Access Compliance Report

Public Rights-of-Way

(Curb Ramps)

Intersection ID: 14349	Main Street: REMOUNT_RD	Cross Street: TOOMEY_AV	Location:	E
ADA ID: 8FAEDF6E697E	Ramp Type: Perp	Initial Pass/Fail: Fail	Overall Compliance: No	Severity Score: 22.5
Codes/Mitigation Info/Possible Solution		Field Measurements/Component Compliance

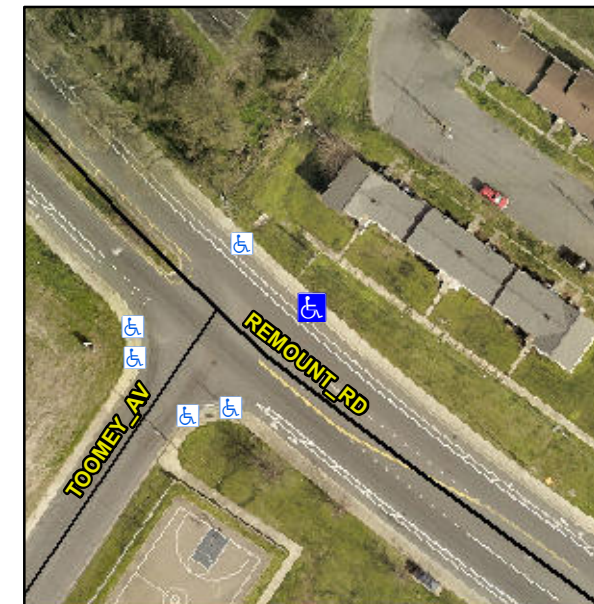
Not Found, R304.5.1, R304.2.2, R304.5.3

Compliance	Description	Data	Compliance	Description	Data
N/A	Ramp Length (in)	60.0	No	Ramp Slope (%)	9.0
No	Ramp Width (in)	47.0	No	Ramp XSlope (%)	4.5
N/A	Flare Type LT	N/A	N/A	Flare Type RT	N/A
N/A	Flare Slope LT (%)	N/A	N/A	Flare Slope RT (%)	N/A
N/A	Flare Traversable LT?	N/A	N/A	Flare Traversable RT?	N/A
N/A	Landing Length (in)	N/A	N/A	DWS Provided?	N/A
N/A	Landing Width (in)	N/A	N/A	DWS Contrast?	N/A
N/A	Landing Slope (%)	N/A	N/A	DWS Length (in)	N/A
N/A	Landing X Slope (%)	N/A	N/A	DWS Full Width?	N/A
N/A	Landing Curb? (Y/N)	N/A	N/A	DWS Offset (in)	N/A
N/A	Shared Landing?	N/A			
N/A	Gutter Ponding?	N/A	N/A	Gutter Slope (%)	N/A
N/A	Gutter Lip Ht (in)	N/A	N/A	Gutter X Slope (%)	N/A
N/A	Painted X Walk1?	No	N/A	Painted X Walk2?	N/A
	X Walk 1 Direction	To SW		X Walk 2 Direction	N/A
N/A	X Walk 1 Width (in)	N/A	N/A	X Walk 2 Width (in)	N/A
	X Walk 1 Slope (%)	6.4		X Walk 2 Slope (%)	N/A
	X Walk 1 X Slope (%)	4.2		X Walk 2 X Slope (%)	N/A

Remove & Replace Entire Ramp.
